#### **ADDENDUM NO. 004**

Brighton Wastewater Treatment System Upgrades

June 2, 2025

RAWING #:

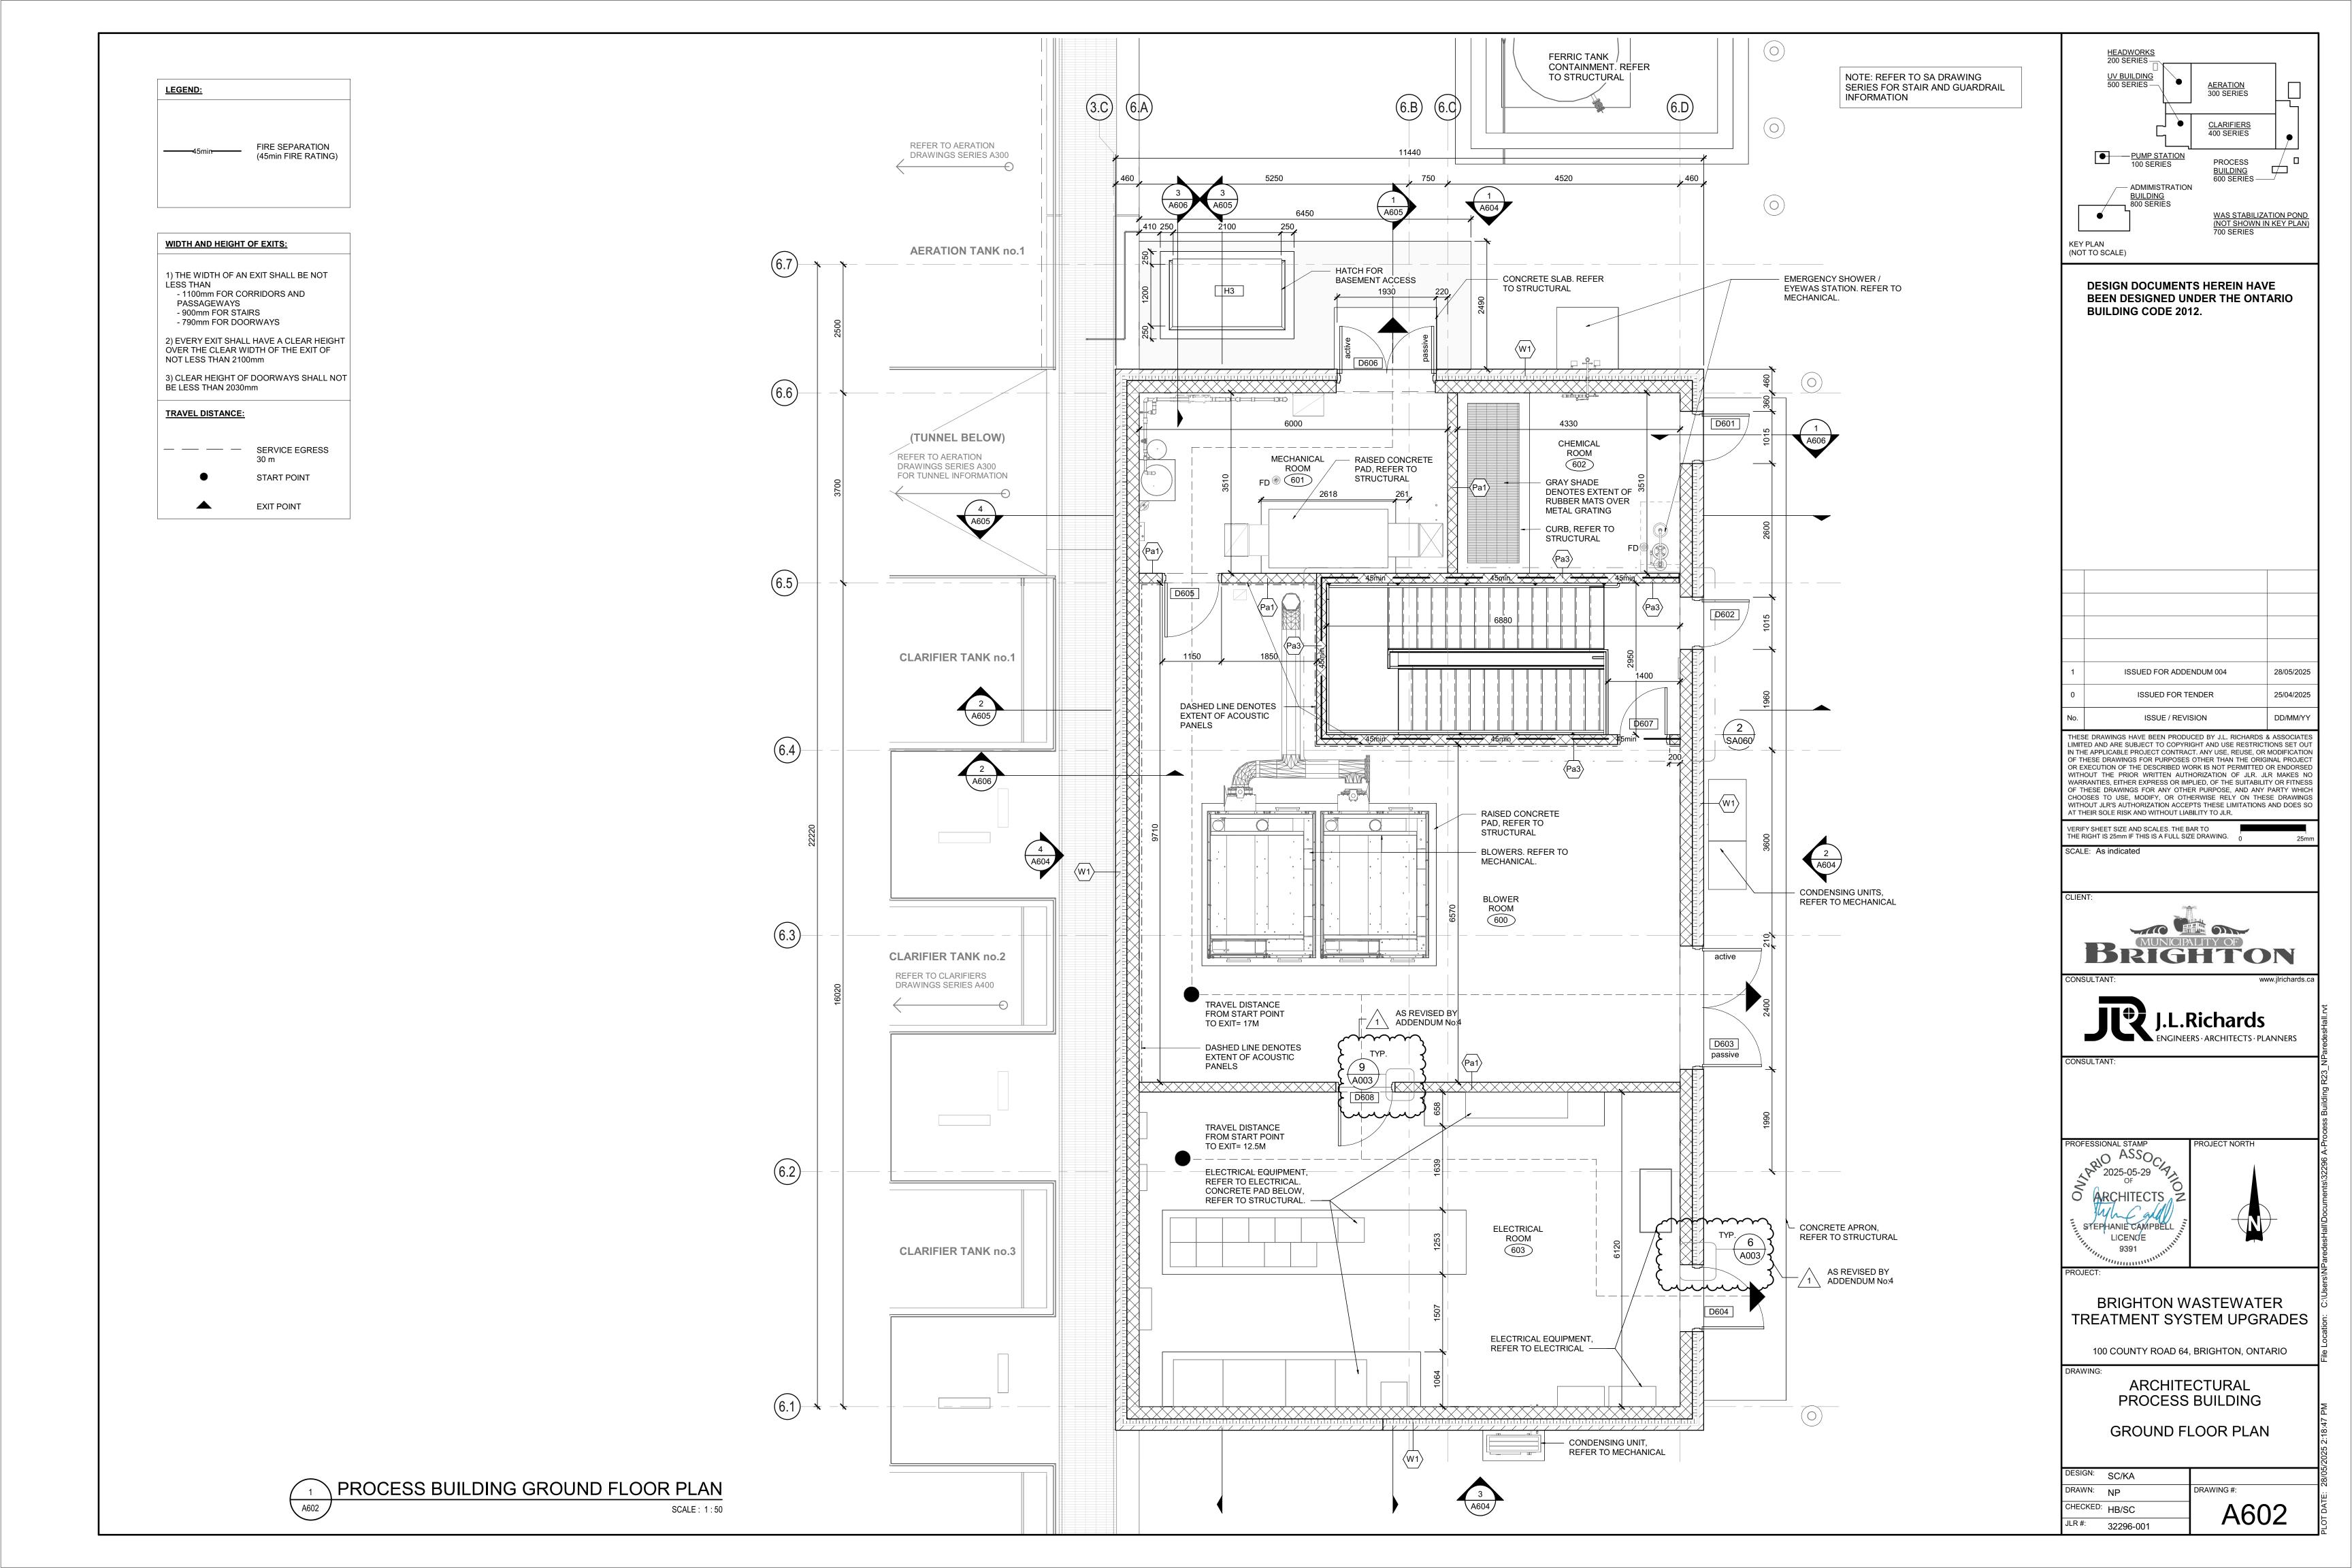
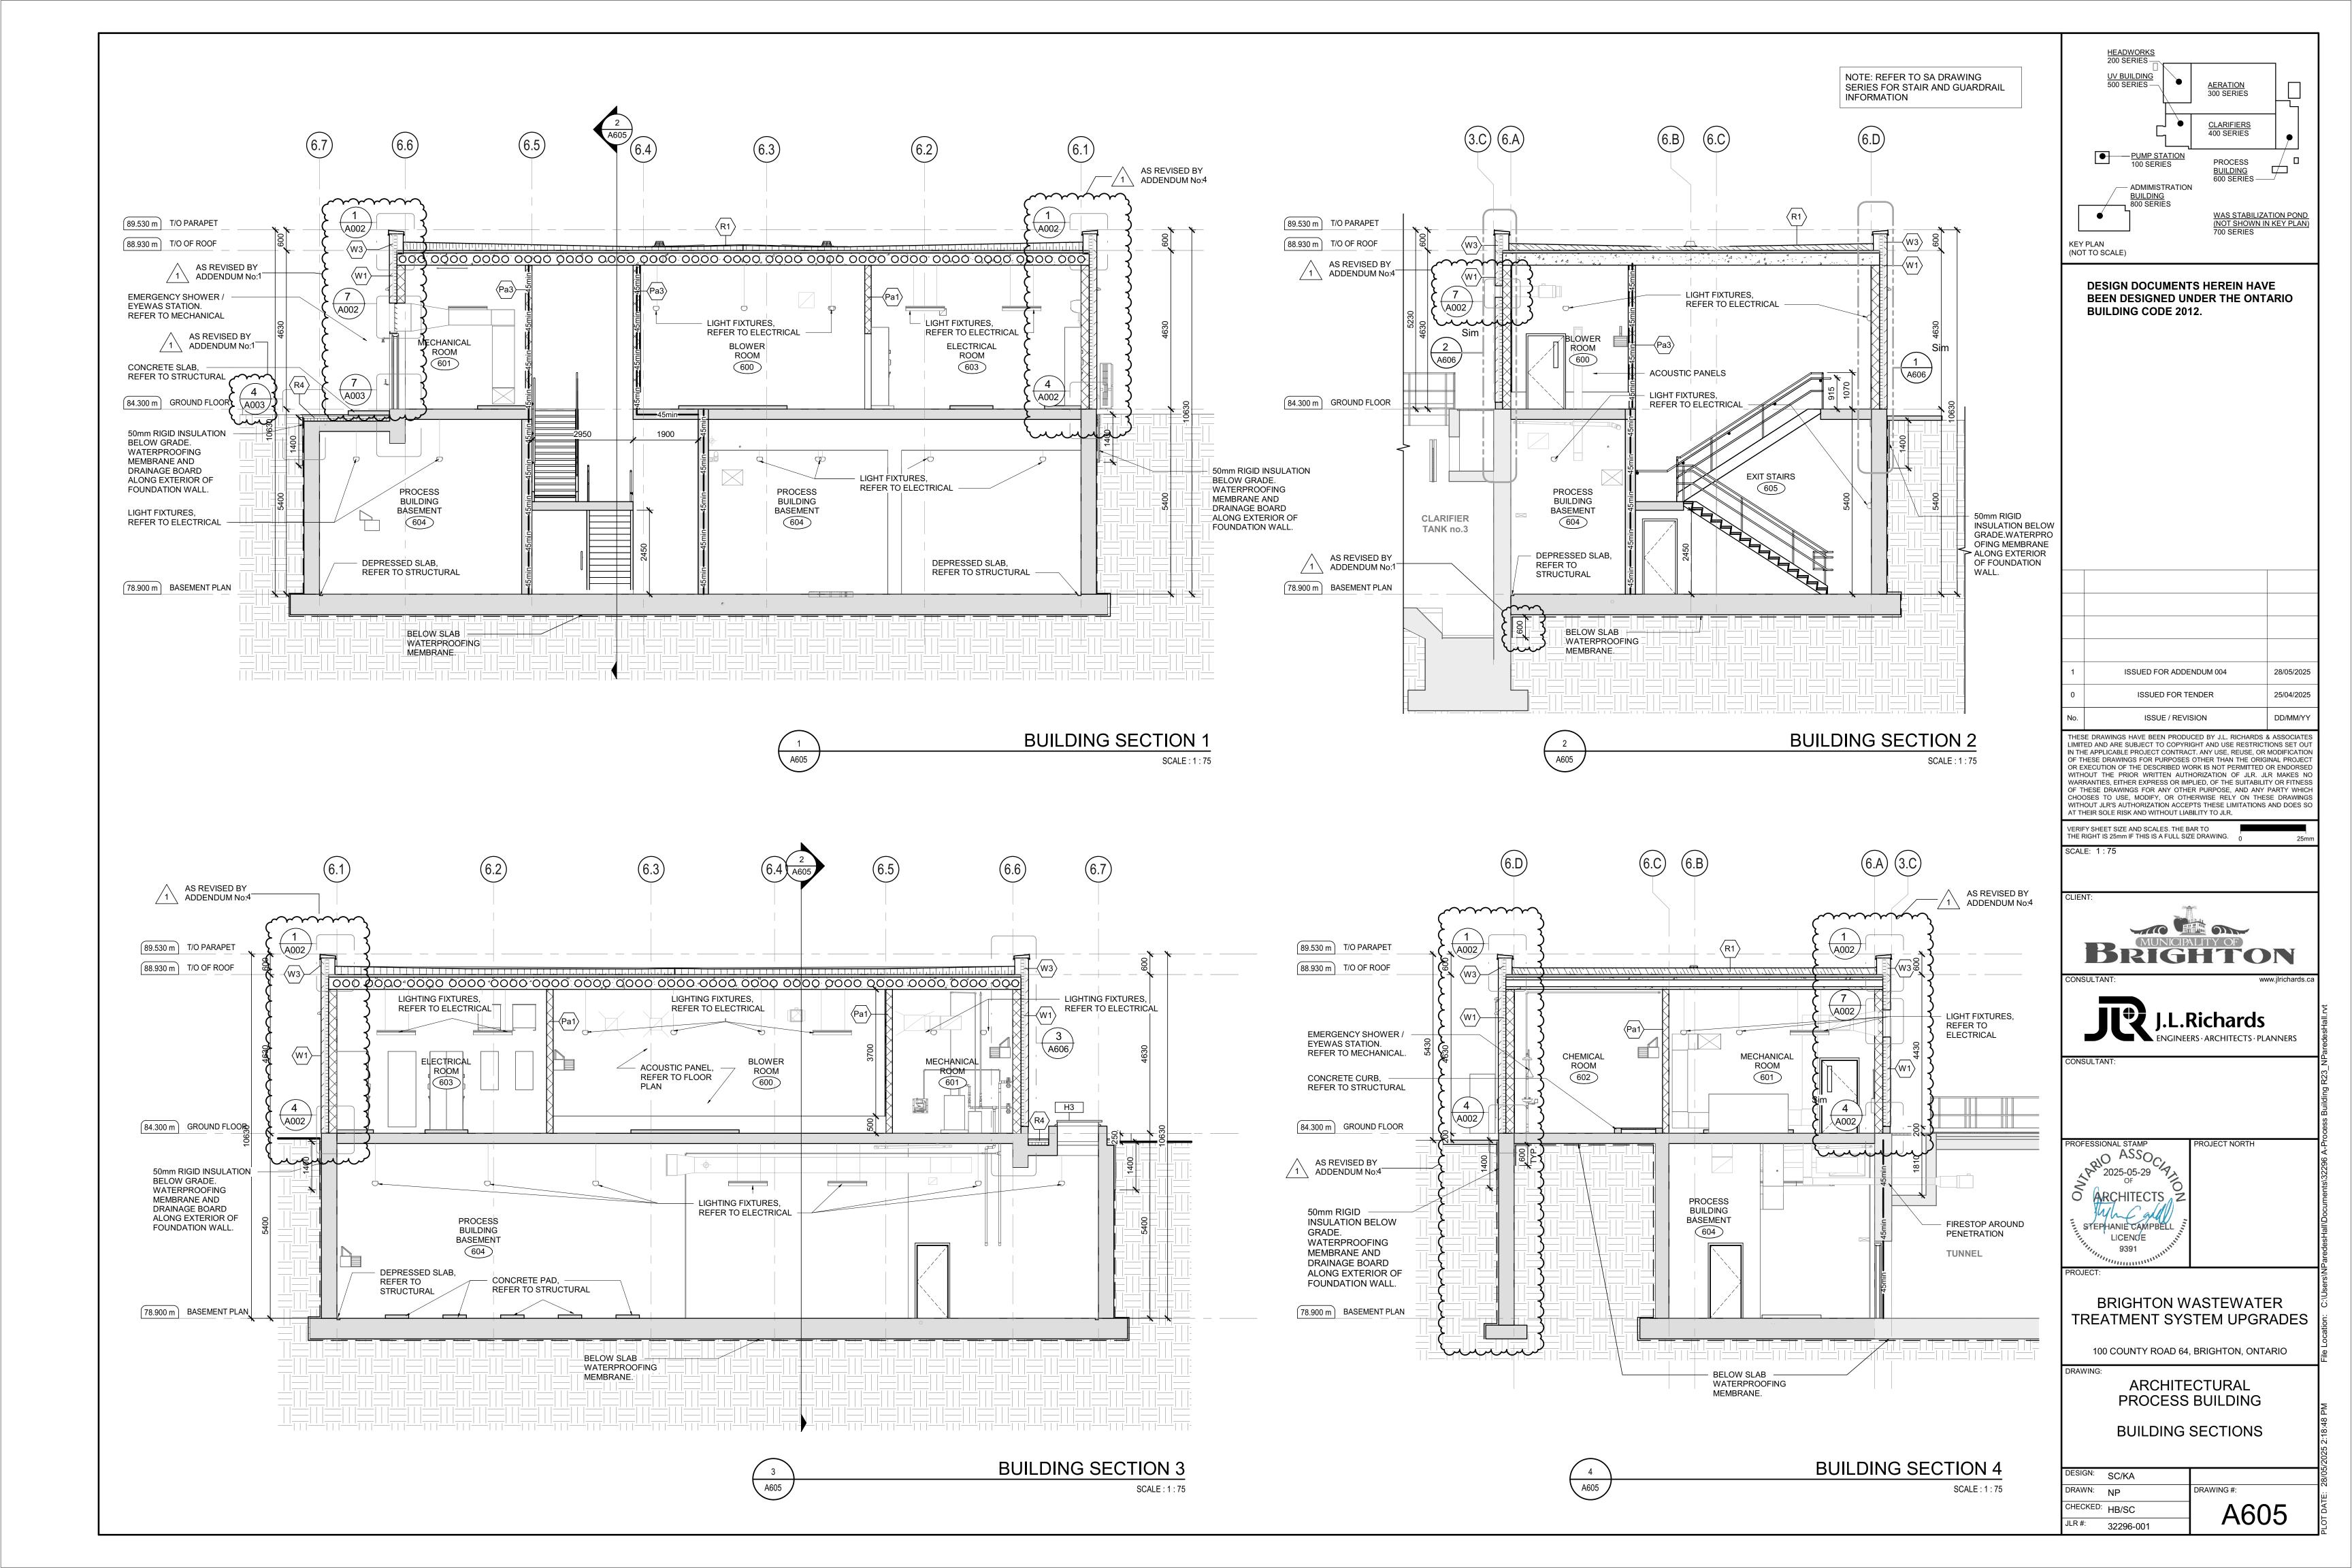
- 12.1 Detail #1
  - .1 **Revise** below grade waterproofing extension as bubbled
  - .2 Add detail 4/A002 callouts and 1/A002.
- 12.2 Detail #2 and #3
  - .1 Add detail 4/A002 callouts and 1/A002.

- 13.1 Detail #1
  - .1 **Revise** below grade waterproofing extension as bubbled.
- 13.2 Detail #2
  - .1 **Remove** below grade waterproofing extension as bubbled.
  - .2 Revise detail 2/A002 callout to read detail 4/A002.
